ADDENDUM NO. 01

**Bid #1472 Campus Entrance Improvements Phase 2
at
Santiago Canyon College**

Project ID #3742, DSA #04-122457

March 13, 2025

Attachment #2 for RFI#6

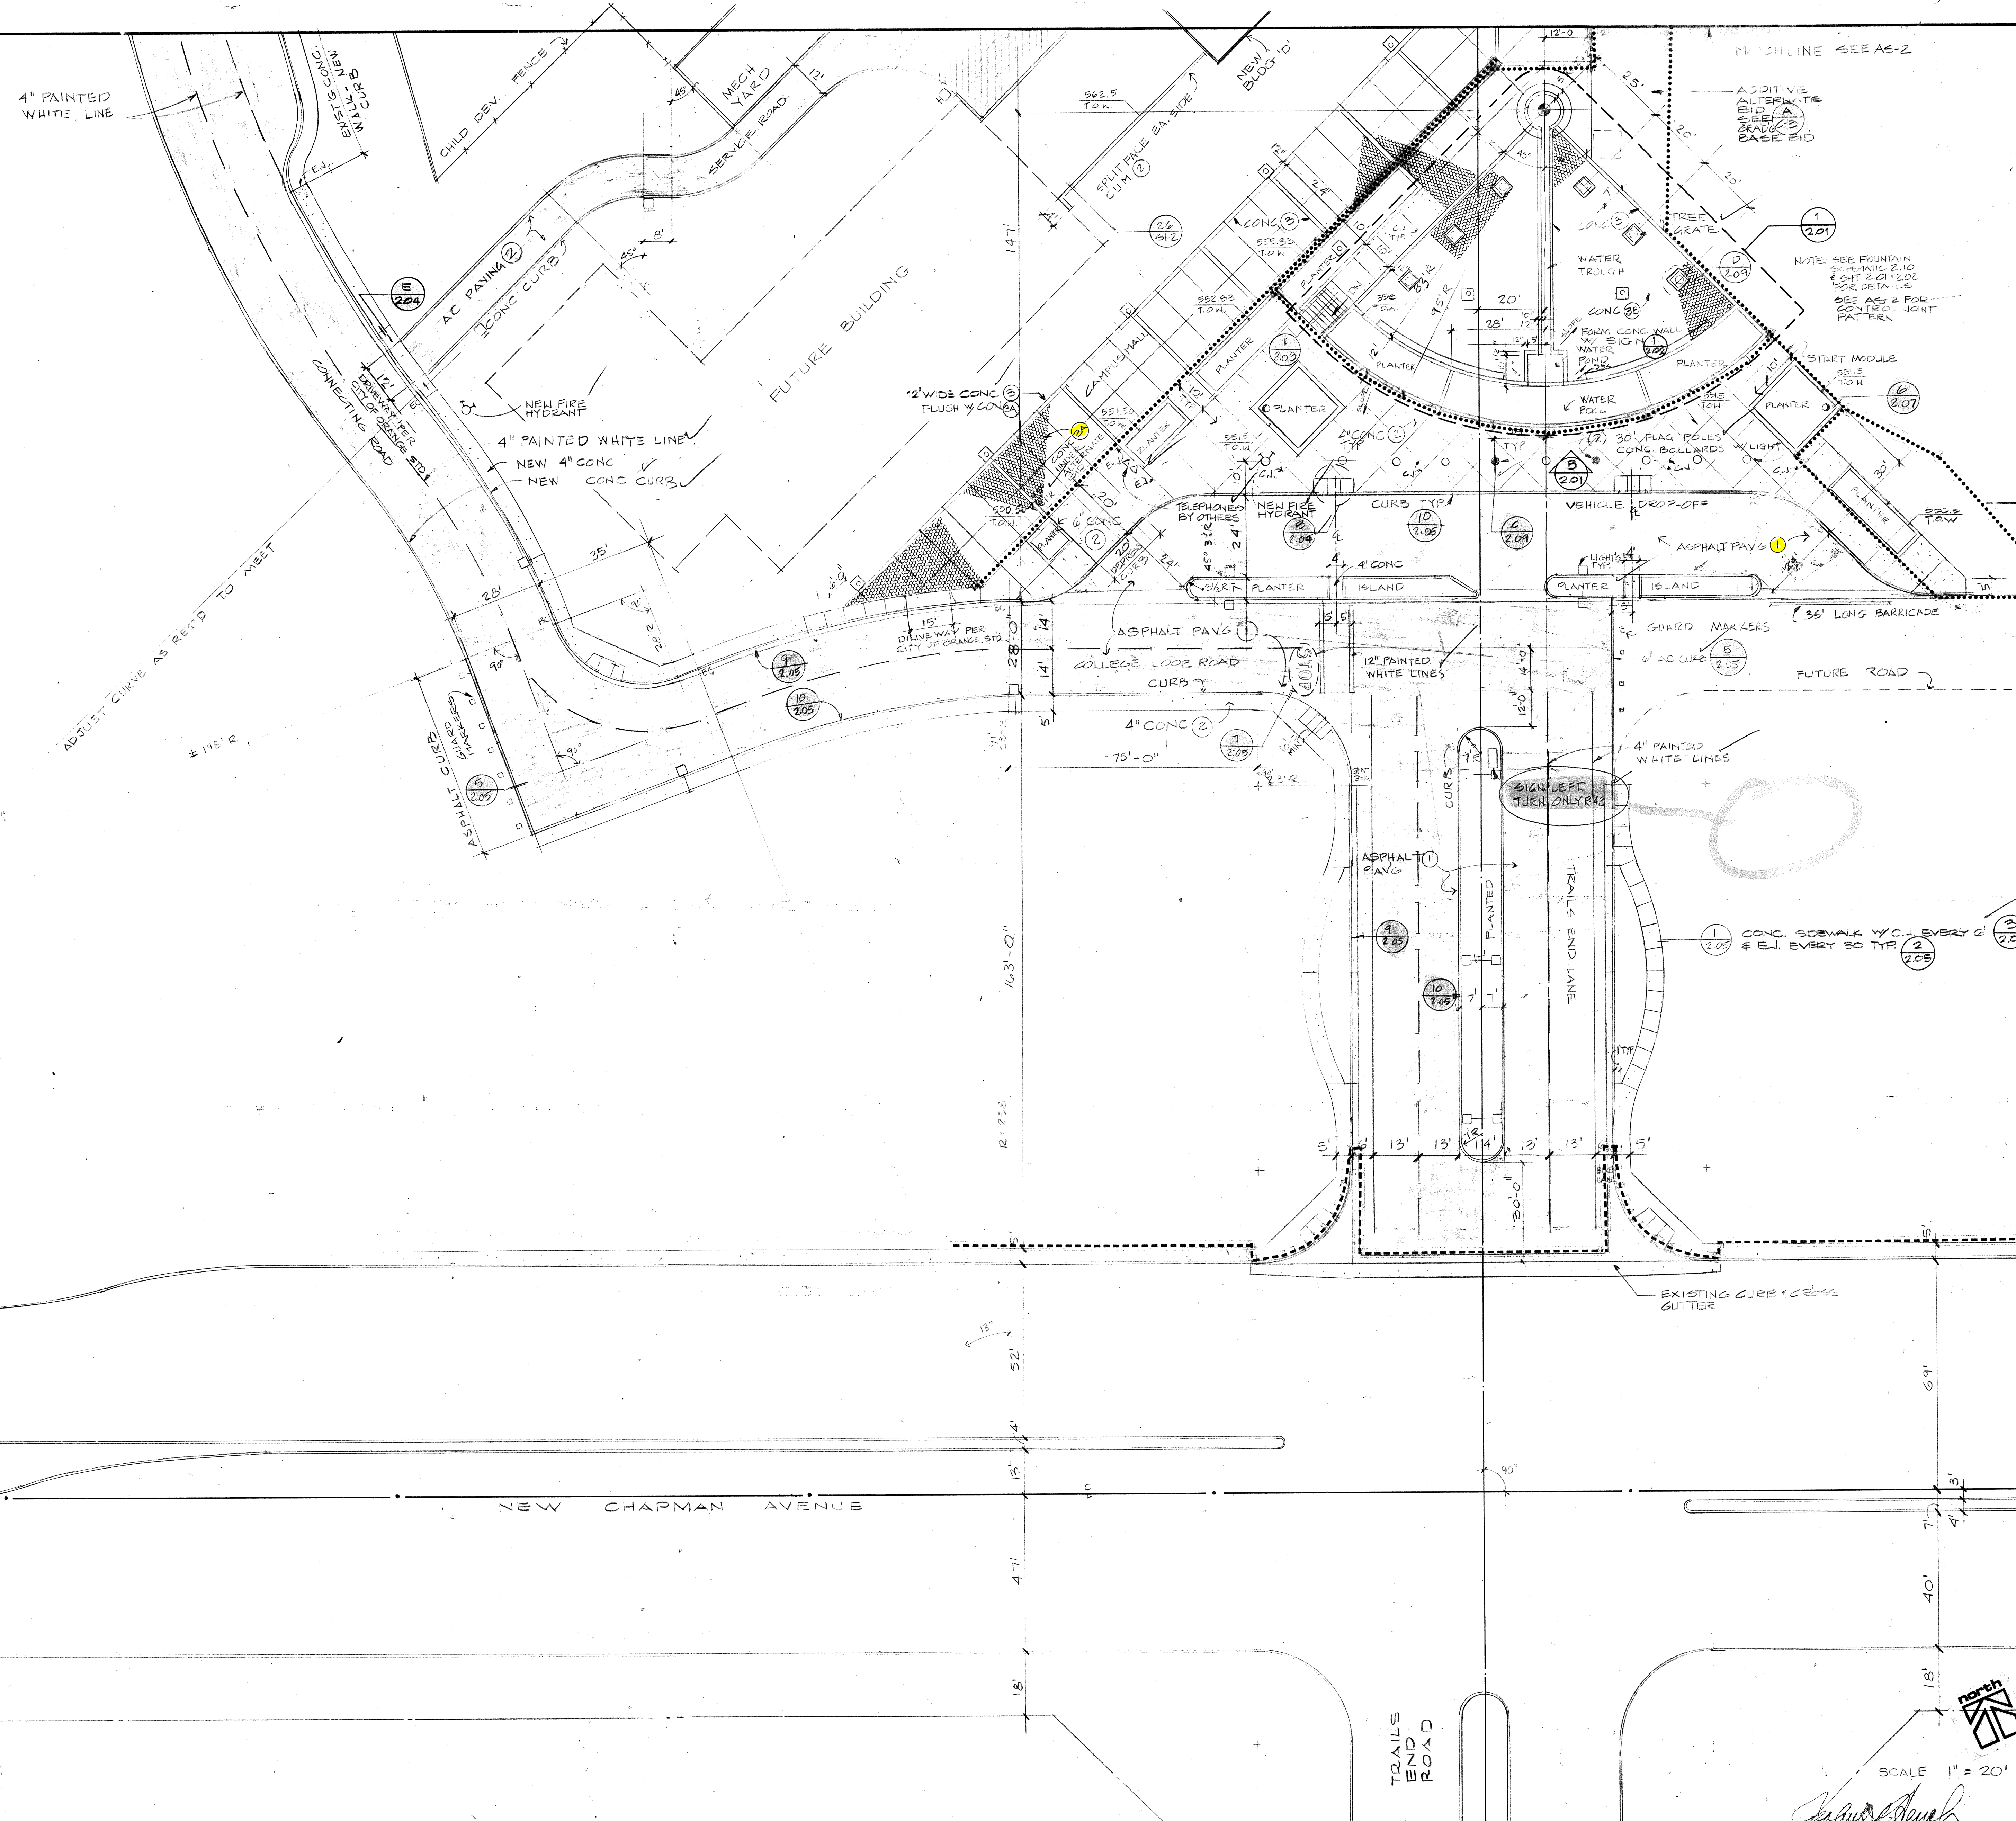
PROJECT NAME:	Campus Entrance Improvements Phase 2 Project at Santiago Canyon College		
PROJECT NUMBER:	3742	BID NUMBER:	1472
EMAIL TO: facilitiesbid@rsccd.edu			
DATE:	3/5/2025		
FROM:	Griffin Mulvey The J.V. Land Clearing Co., Inc.	EMAIL:	griffin@thejvco.com
SPEC SECTION:	Demolition / Existing Conditions	DRAWING NUMBER:	CD-1.0
REQUESTED CLARIFICATION:			
<p>Question 1: Soils report does not identify the thickness of the asphalt dropoff / firelane area that is getting demolished. Soils report does not identify if the asphalt contains petromat in this area. Boring B-1 identified AC pavement to be 2.5" thick but does not provide asphalt thickness in area getting demolished.</p> <p>Question 2: Soils report does not identify thickness of concrete / brick firelane that is getting demolished. P-2 identified concrete to be 4" thick but does not provide concrete thickness in firelane area getting demolished.</p>

RESPONSE TO CLARIFICATION:			
<p>Response to Question 1: Refer to "Attachment #1 for RFI#6" for locations of asphalt thickness.</p> <p>RSCCD, 3/13/2025</p> <p>Response to Question 2: Per as-builts provided by the District, the thickness of concrete / brick fire lane getting demolished is 6-inches thick - see attached As-built sheet 'AS-2' and "Attachment #2 for RFI#6"</p> <p>SVA, 3/13/2025</p>

Asphalt thickness: ~4"

Asphalt thickness: ~5.5"

FOUNTAIN
ELECTRICAL
PLANS &
DETAILS

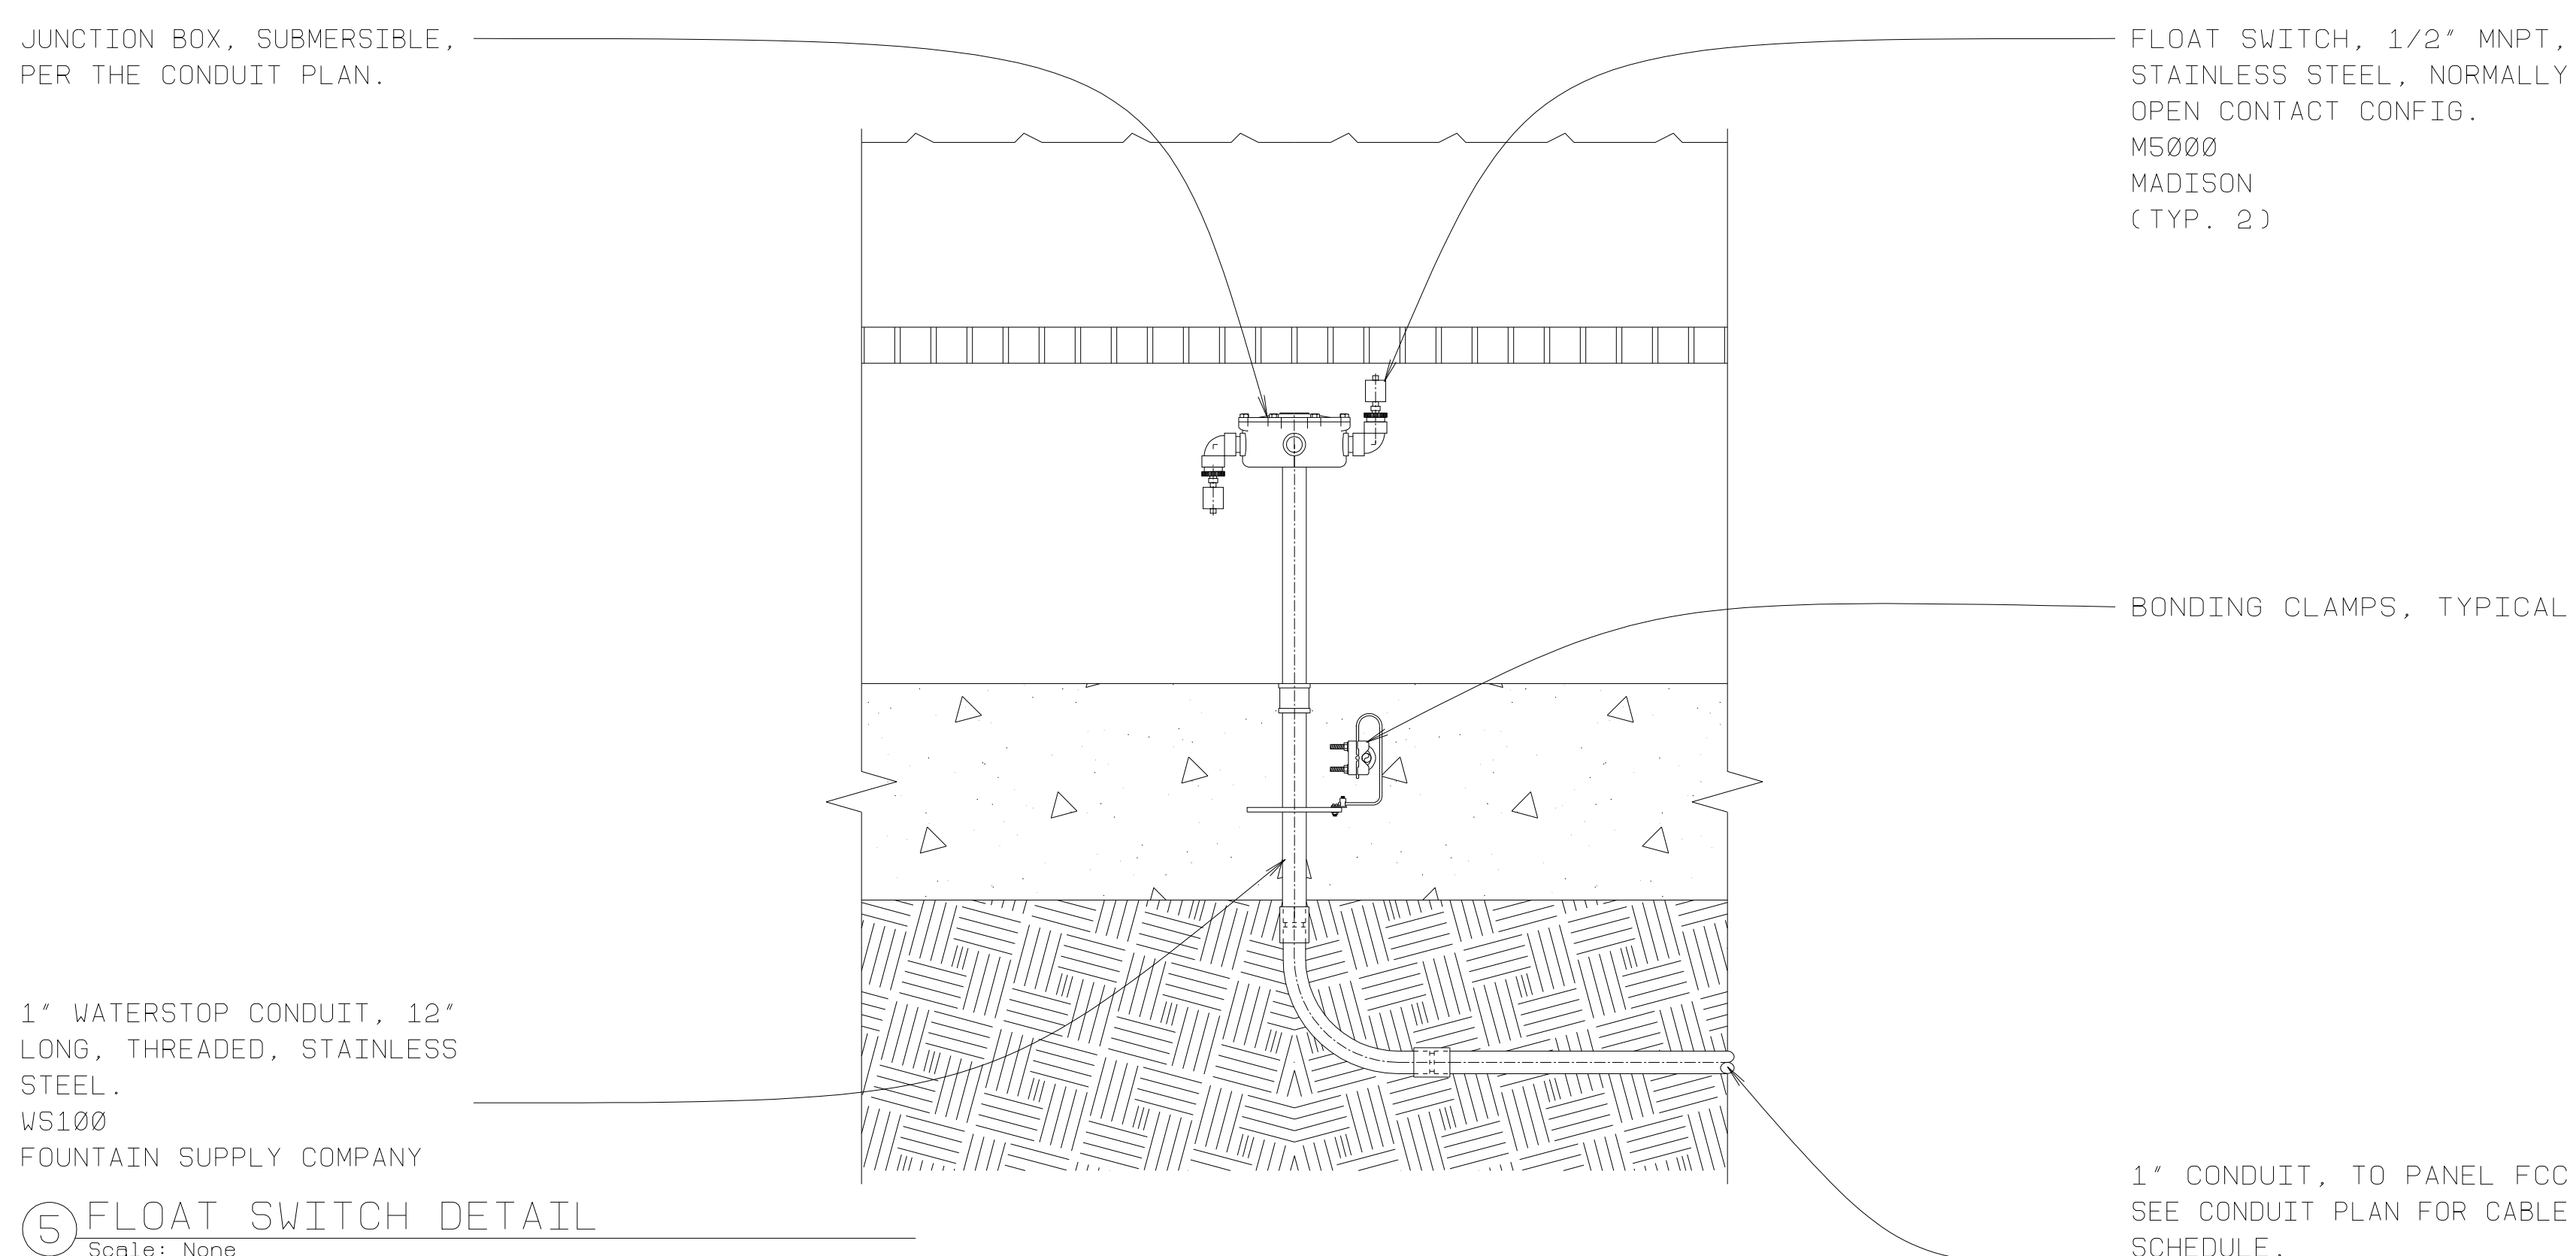
PROJECT NAME:	Campus Entrance Improvements Phase 2 Project at Santiago Canyon College		
PROJECT NUMBER:	3742	BID NUMBER:	1472
EMAIL TO: facilitiesbid@rsccd.edu			
DATE:	3/5/2025		
FROM:	Ryan Agnew - RJR Water Features	EMAIL:	ragnew@rjrwaterfeatures.com
SPEC SECTION:	Electrical/Controls	DRAWING NUMBER:	F-1.06 & F-1.07
REQUESTED CLARIFICATION:			
<p>The equipment load schedule on F-1.06 and the electrical schematic on F-1.07 do not match.</p> <p>F-1.06 matches the equipment shown throughout the plans, while F-1.07 has multiple additional items not shown on the plans.</p> <p>Please advise if a revised electrical schematic will be provided.</p>			
RESPONSE TO CLARIFICATION:			
<p>Please use Addendum 2, revised electrical sheets F-1.05, F-1.06, and F-1.07.</p> <p>SVA, 3/13/2025</p>

PROJECT NAME:	Campus Entrance Improvements Phase 2 Project at Santiago Canyon College		
PROJECT NUMBER:	3742	BID NUMBER:	1472
EMAIL TO: facilitiesbid@rsccd.edu			
DATE:	3/5/2025		
FROM:	Ryan Agnew - RJR Water Features	EMAIL:	ragnew@rjrwaterfeatures.com
SPEC SECTION:	Electrical/Controls	DRAWING NUMBER:	F-1.06
REQUESTED CLARIFICATION:			
<p>Clarification is needed on the fountain lighting controls. Is the fountain control panel providing power AND control for the lights located in the fountain basins, or are the lights being controlled by an external controller?</p>			
RESPONSE TO CLARIFICATION:			
<div style="border: 2px solid green; padding: 10px; margin-top: 10px;"><p>The fountain control will provide lighting power. Please use Addendum 2, revised electrical sheets F-1.05, F-1.06, and F-1.07.</p><p>SVA, 3/13/2025</p></div>

- A. **F-1.05 – Detail 1:** The wiring and conduit for the light power supplies have been relocated to the West J-box for ease of installation.
- B. **F-1.05 – Detail 2:** Filter pumps have been included in the detail.
- C. **F-1.06 – Detail 1:** The electrical plan has been updated to reflect new light fixtures and power supply layout. The originally specified lights are no longer available.

- D. **F-1.07 – Details 1 thru 4:** The electrical schematics have been updated to include the three new lighting circuits.
- E. **F-1.07 – Detail 2:** Float switch detail has been included.
